STATE OF MAINE
DEPARTMENT OF TRANSPORTATION
16 STATE HOUSE STATION
AUGUSTA, MAINE 04333-0016

December 17, 2018
Subject: Piscataqua River Bridge Wearing
Surface Replacement
State WIN: 019270.00
Location: **Kittery & Portsmouth, N.H.**
Amendment No. 3

Please make the following changes to the Bid Documents:

STATE OF MAINE DEPARTMENT OF TRANSPORTATION	AC-IM-1927(000)E	BRIDGE NOS. 6330	WIN 019270.00	BRIDGE PLANS
KITTERY - PORTSMOUTH BRIDGE OVER PISCATAQUA RIVER KITTERY-PORTSMOUTH YORK COUNTY				
COMPRESSION SEAL EXPANSION JOINT 1				
SHEET NUMBER				
210A				
OF 232

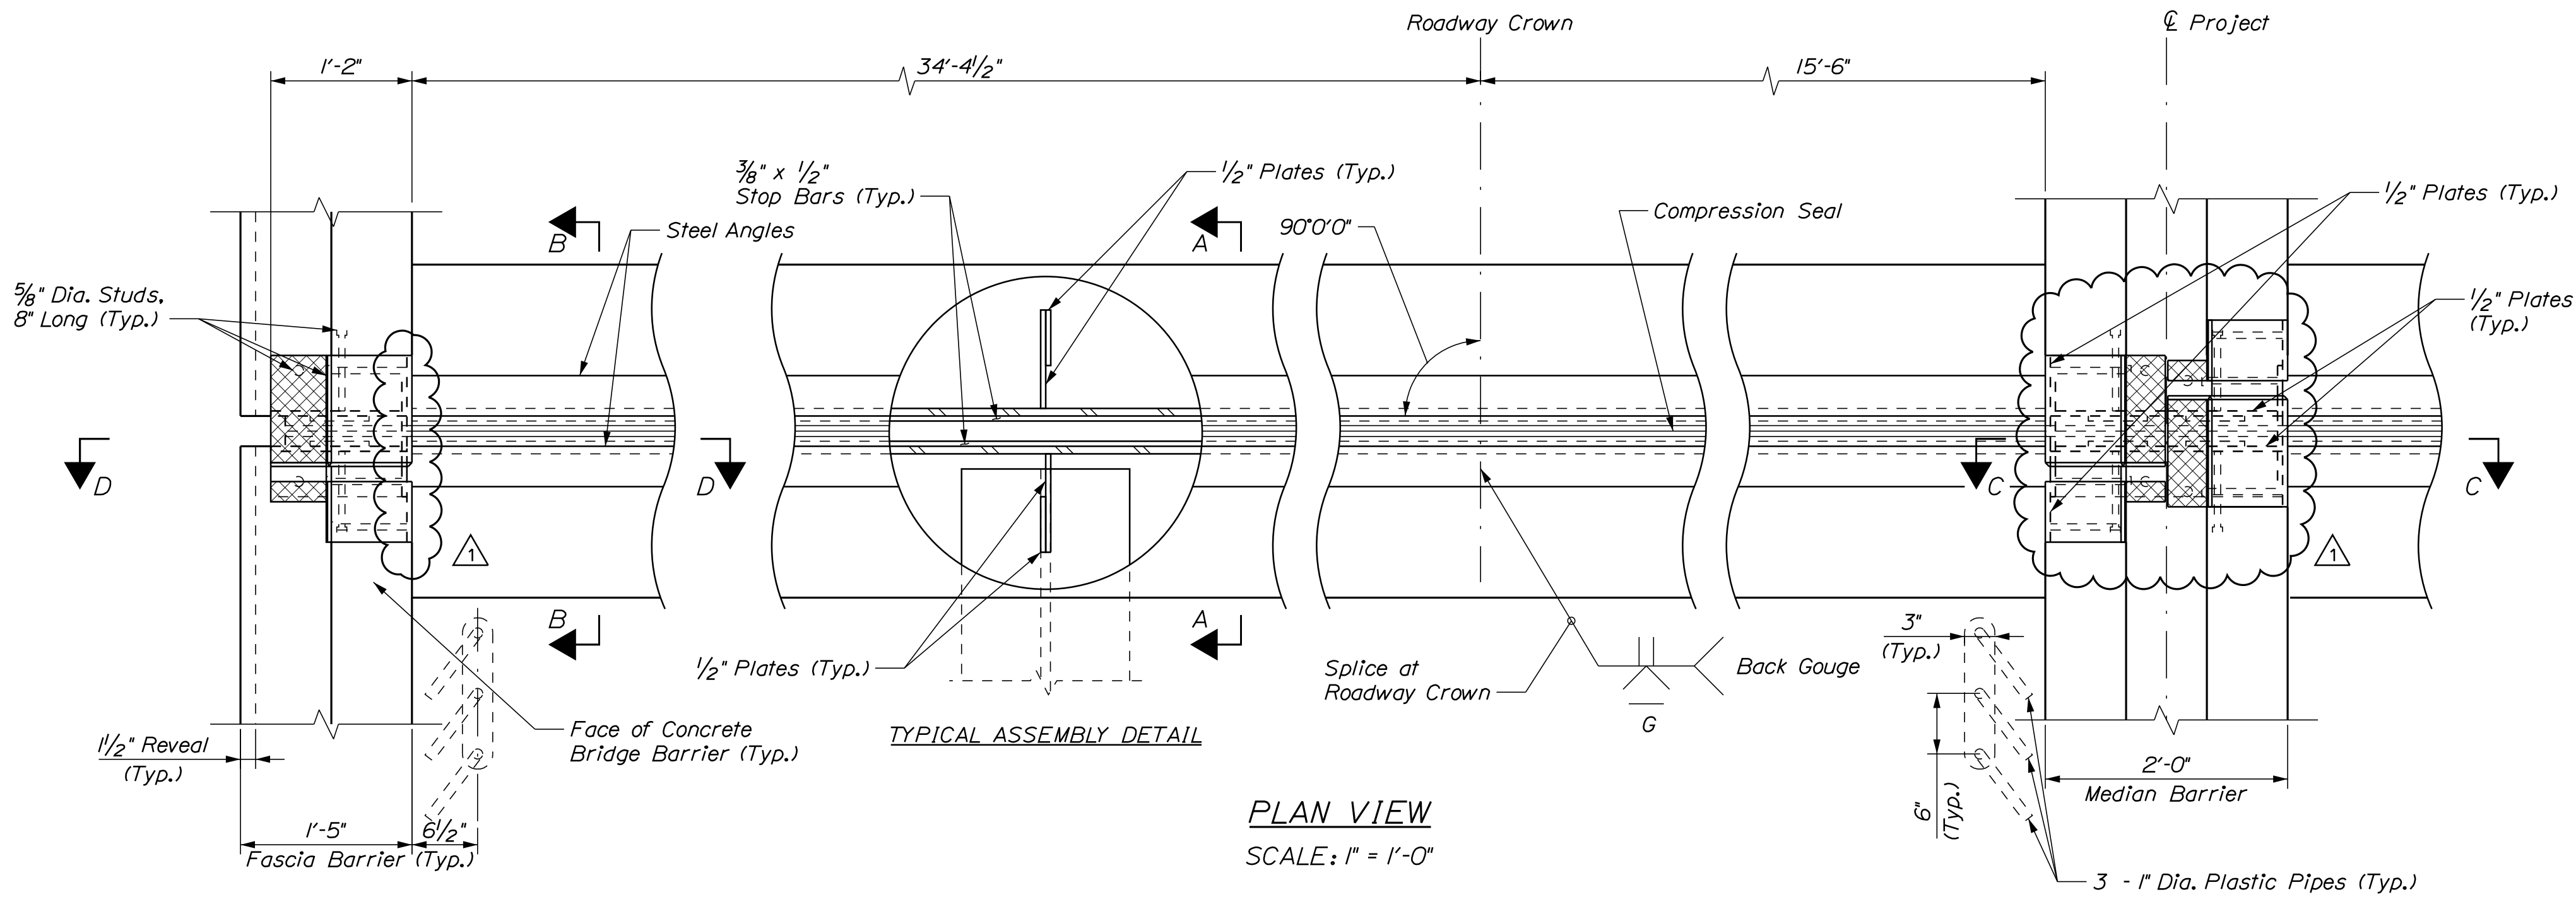
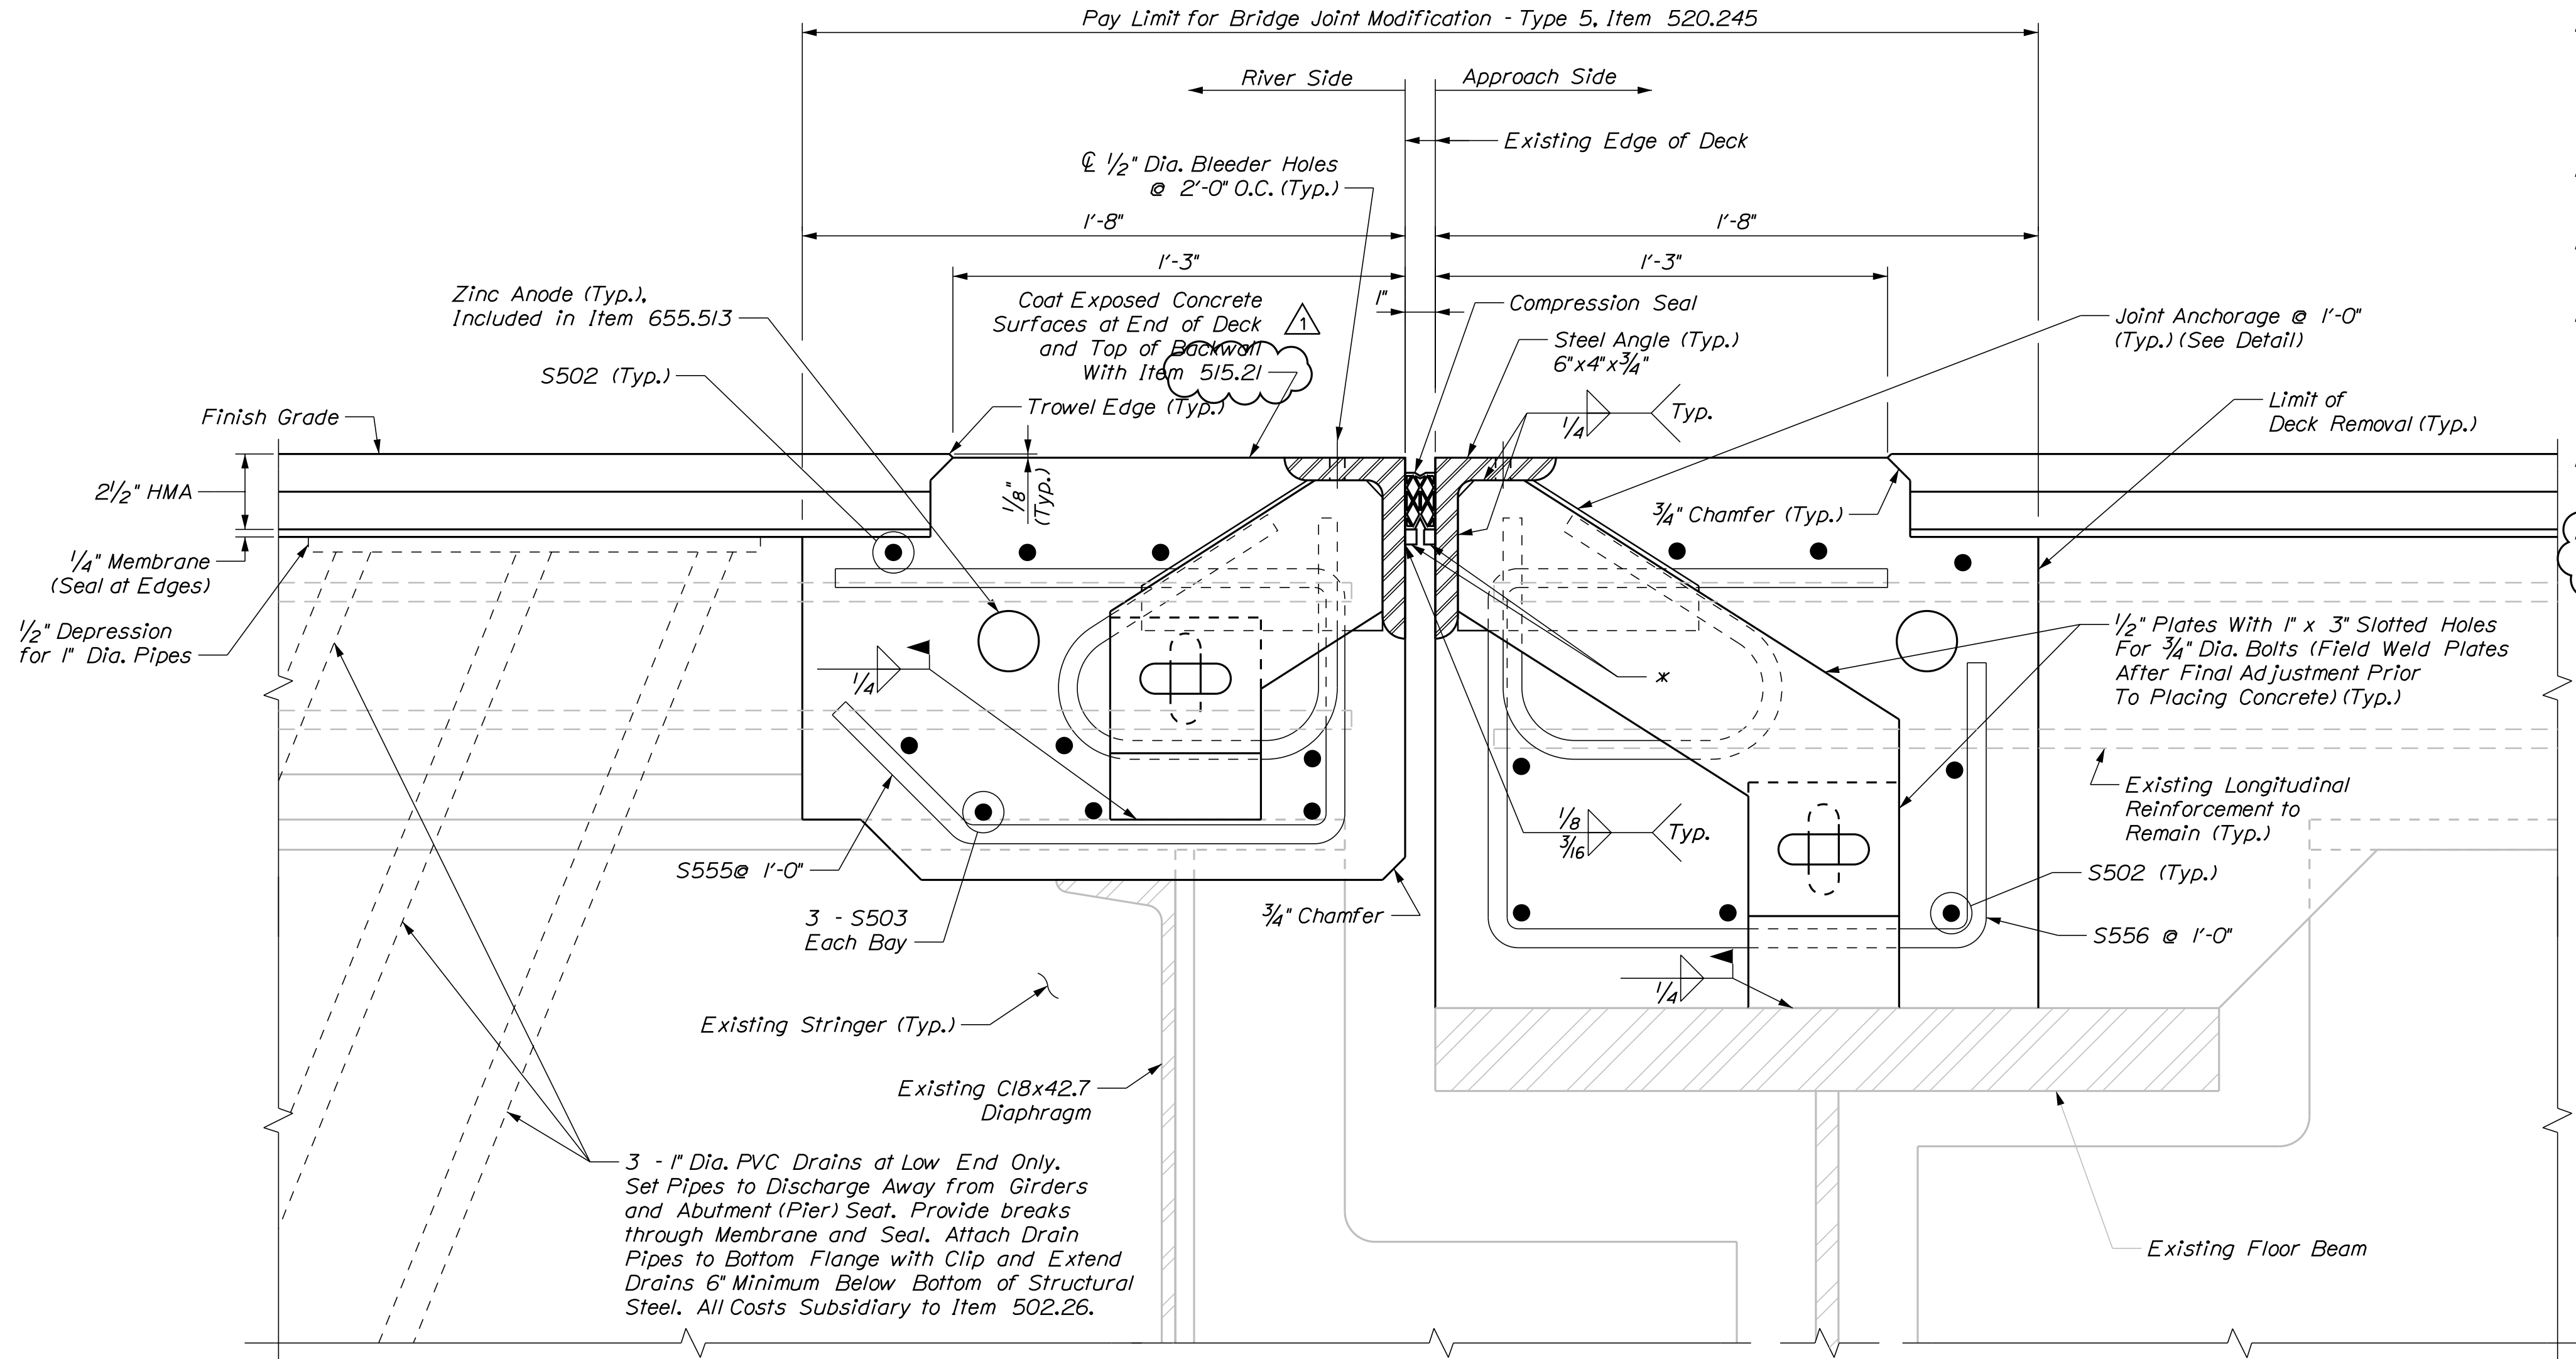
Question: Sheet 210 of 230 has the detail for the compression seal expansion joint. Reinforcing in Section A-A, labeled as S502 shows 8 Each, and S503 shows 9 EA Longitudinal Bars. The Reinforcement schedule (per Joint) shows 14 EA of S502 and 18 EA of S503. Please clarify which is correct?

Question: Please reference Contract Drawing number 210, Section A-A. The note on the left of this section directs for the installation of (3) Three 1" PVC pipes thru the existing deck on the low side of the new expansion joints.

- a. Is the PVC to be Schedule 40 or 80?
- b. Are the PVC Pipes required to be installed on an angle as is shown on the plan sheet?
- c. Can you confirm that there are 72 sets of (3) pipes each on the northbound and 72 Sets of (3) pipes each on the southbound roadway? (36 Joints x 2 Locations at each joint, per each side of the median barrier NB and SB)
- d. Please elaborate what "provide breaks thru the membrane and seal" means relative to the $\frac{1}{2}$ " depression called for on the plans sheet.

Response: The plan quantities are correct. There are 6-S502 on the left side of the joint and 8-S502 on the right side, 14 total per joint. There are 3 sets of S503 in each of the 6 bays between stringers, 18 total per joint.

Response: Please note that the drains are to be placed at the low end of the deck, i.e. high side of the joint.

- a. Schedule 40.
- b. The angle shown is schematic. The drains must be oriented to clear structural steel and substructures as indicated.
- c. The number of drains at the expansion joints is correct. Note that additional drain tubes are required at bridge drains as shown on Sheet 212.
- d. The membrane shall be punctured to allow seepage into the drain tubes. The interface between the tubes and the membrane shall be sealed to prevent seepage from reaching the concrete deck.
